EVALUATION  
OF  
HYDROSTATIC TESTING OF THE FIRE PROTECTION YARD PIPING  
AT  
FERMI 2  
DETROIT EDISON CO.

Prepared by: Robert J. O'Laughlin, P.E., CSP  
Senior Fire Protection Engineer  
Professional Loss Control, Inc.

EVALUATION OF GANGED  
MULTI-DAMPER ASSEMBLIES  
AT  
FERMI 2

SKETCH #2  
 ZONE 13AB  
 VENTILATION EQUIP. AREA  
 EL. - 659'-6"

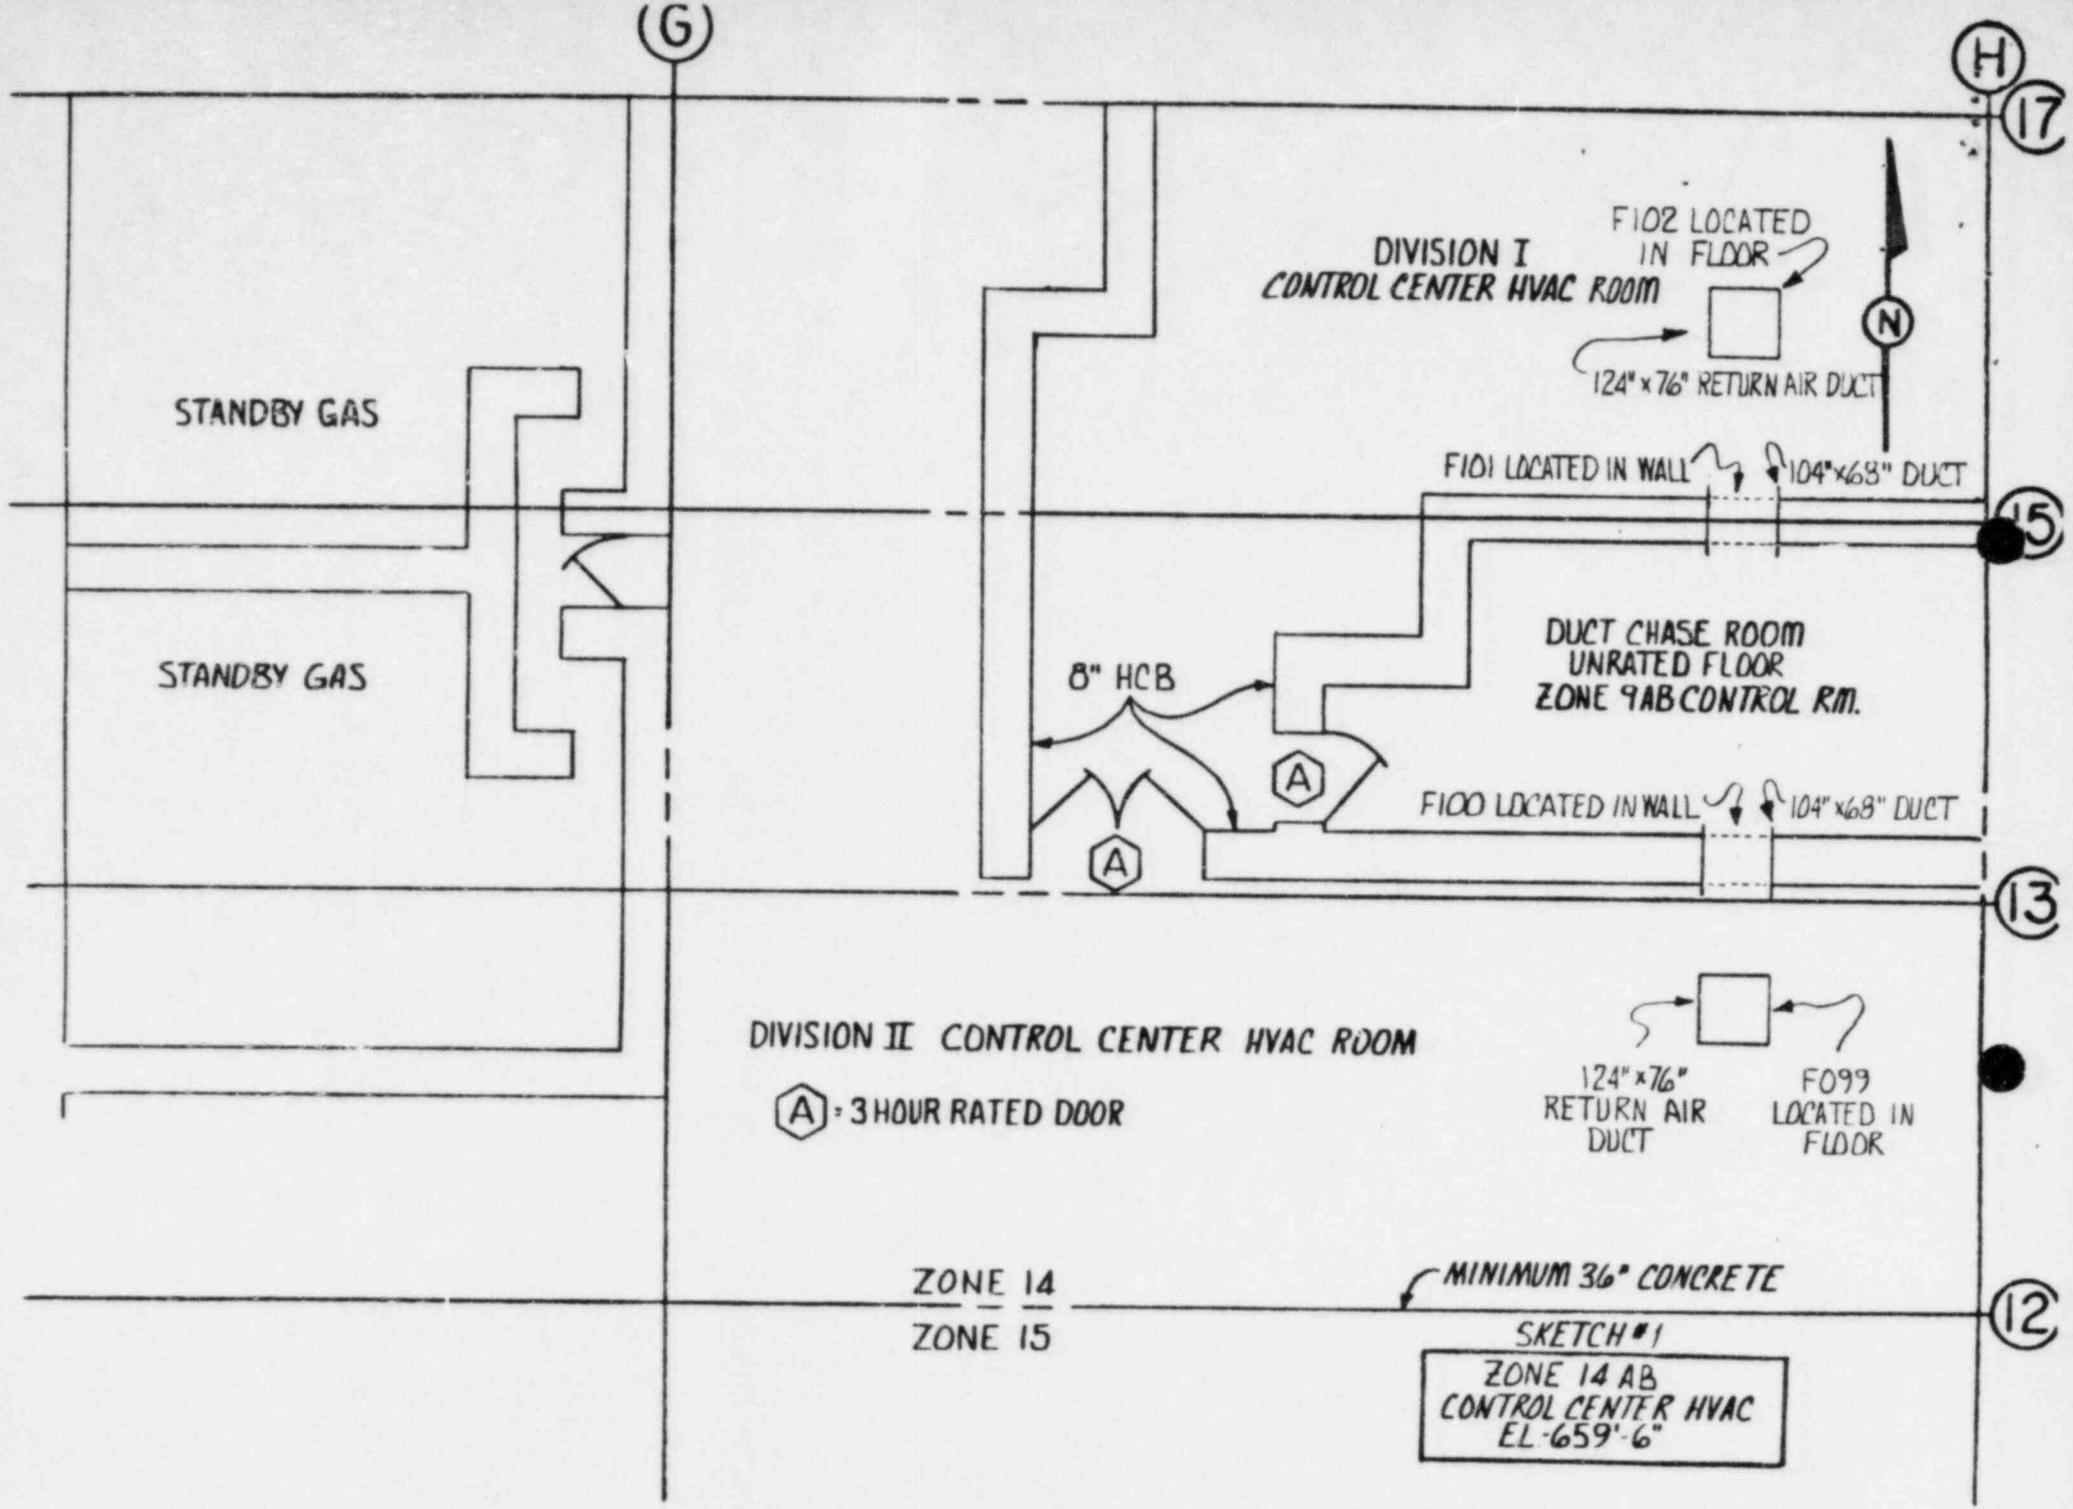
FO 90 is a 84" x 84" assembly which is four inches wider than the 1.5 hour tested assembly. However, the overall assembly area size of FO 90 is 7056 sq. inches, while the test assembly size was 9600 sq. inches. Accordingly, Edison believes the test results of the tested assembly (1.5 hour rating) are applicable to FO 90. This 1.5 hour rating for FO 90 is acceptable for this damper based on the low combustibile loading of zone 13 and the pipe chase.

FO 85 is a 74" x 30" assembly which is 2 inches wider than the 3 hour tested assembly. However, the overall assembly area size of FO 85 is 2220 sq. inches, while the test assembly area size was 5184 sq. inches. Accordingly, Edison believes the test results of the tested assembly (3 hours) are applicable to FO 85. Another consideration is that the tested assembly size for 1.5 hours is 120" x 80". The 1.5 hour rating is acceptable because of the low combustibile loadings of zones 13 and 9.

SKETCH #1  
ZONE 14 AB  
CONTROL CENTER HVAC  
EL. 659'-6"

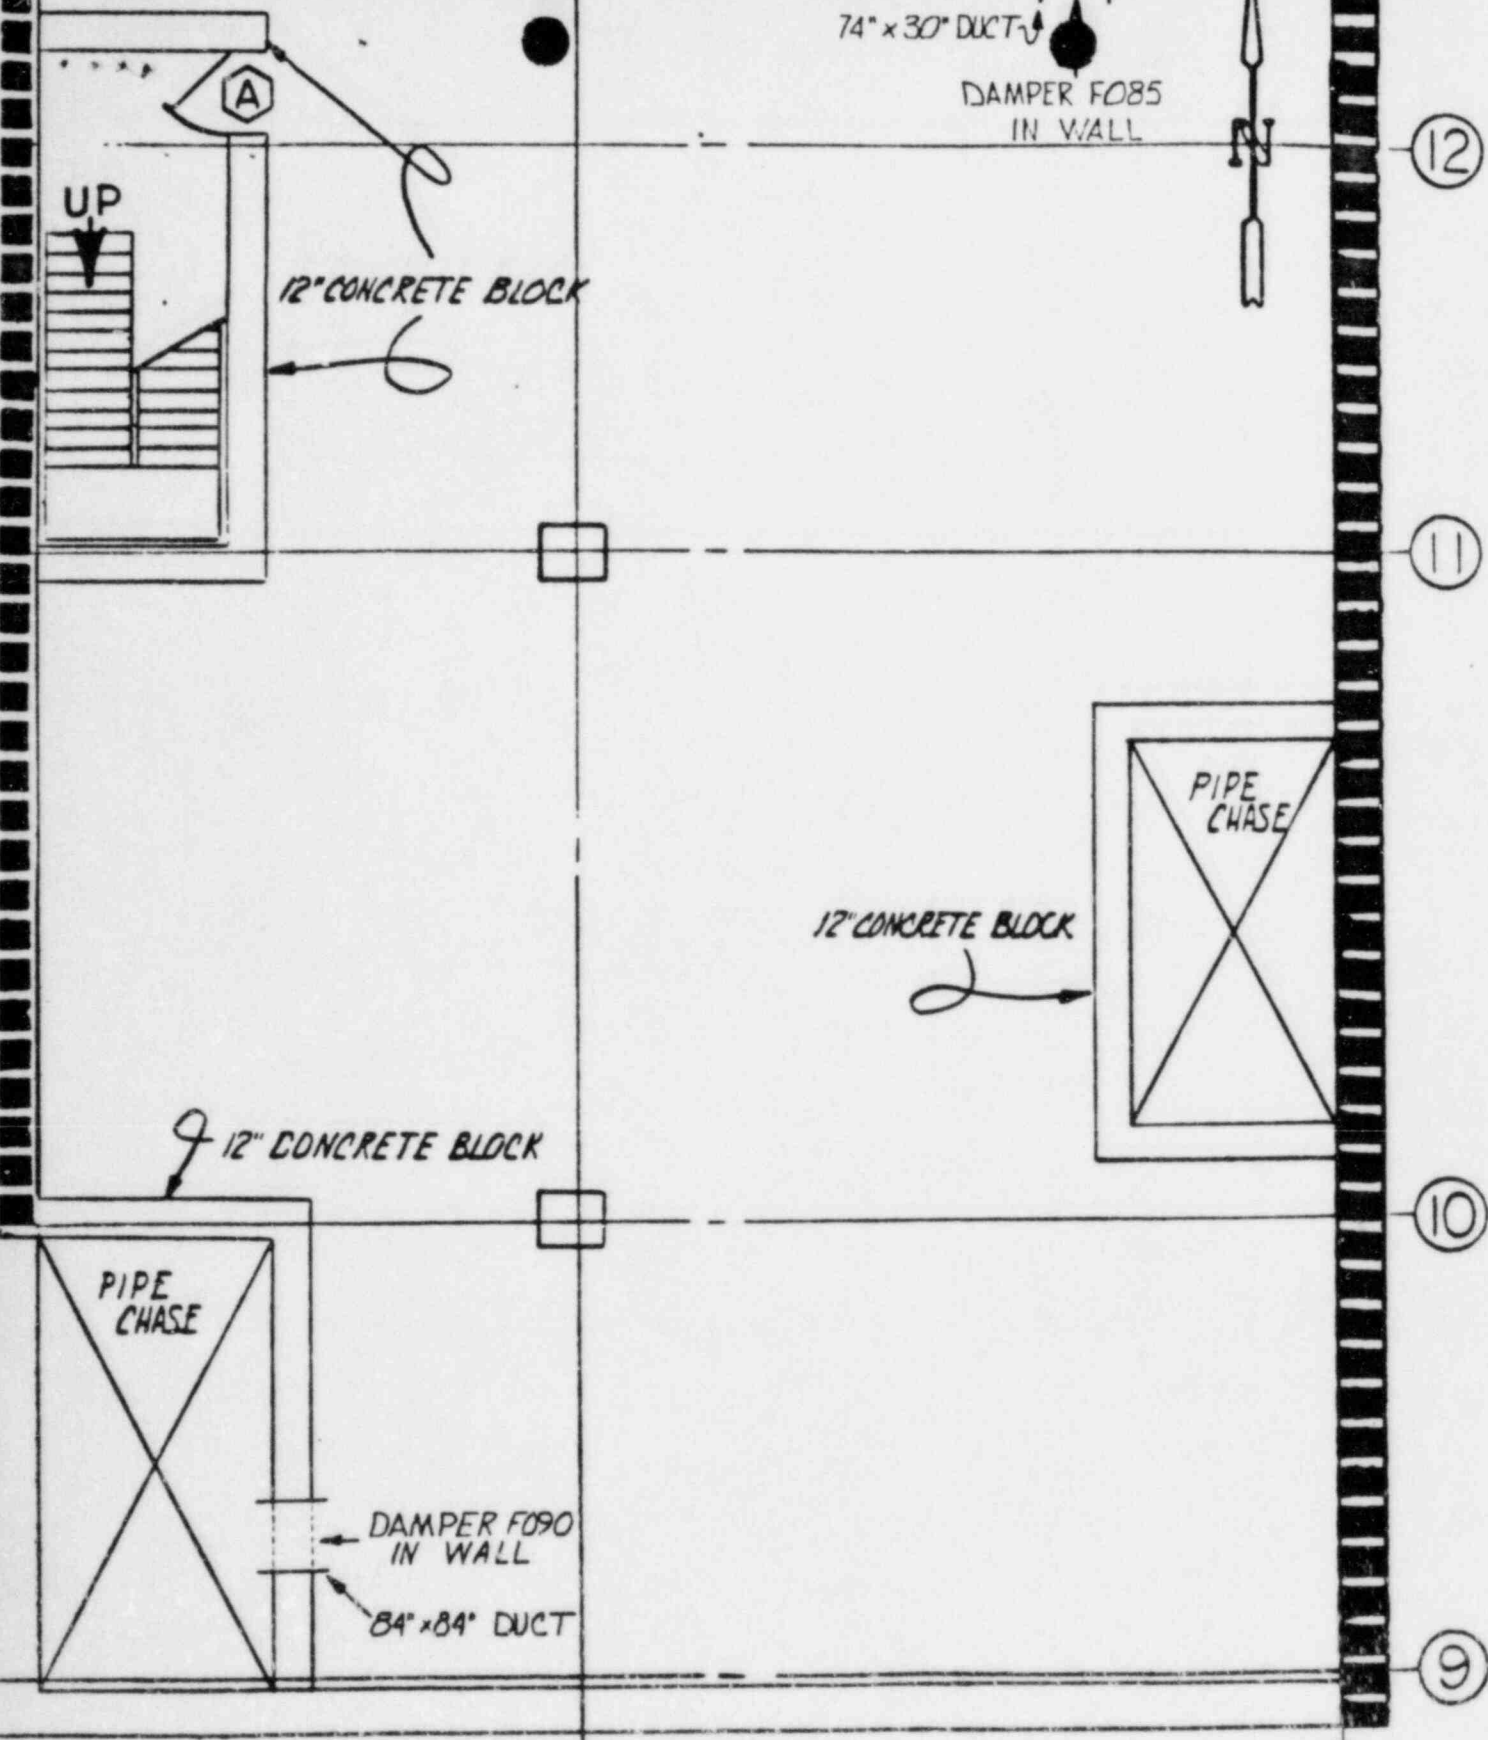
F0 100 is located in a wall with a minimum one hour rating. This size opening 104" x 68" has been tested for a 1.5 hour rating which is an acceptable fire rating for the fire loading located in each zone.

F0 99 is located in the floor. Damper installation has been sectioned into 3 sets of 8 dampers each (76" x 41"). This size is within the 1.5 hour rating for horizontal openings. The material sub-dividing the opening is a 6" x 76" 10 gage steel plate. Each damper weighs approximately 14 pounds. This steel bar will provide the necessary fire resistance because of the very low combustible loading in each zone.

FO 101 is located in a wall with a minimum one hour rating. This size opening 104" x 68" has been tested for a 1.5 hour rating which is an acceptable fire rating for the fire loading located in each zone.

FO 102 is located in the floor. The opening has been sectioned into 3 sets of 8 dampers each. (76" x 41") This size is within the 1.5 hour rating for horizontal openings. The material sub-dividing the opening is a 6" x 76" 10 gage steel plate. Each damper weighs approximately 14
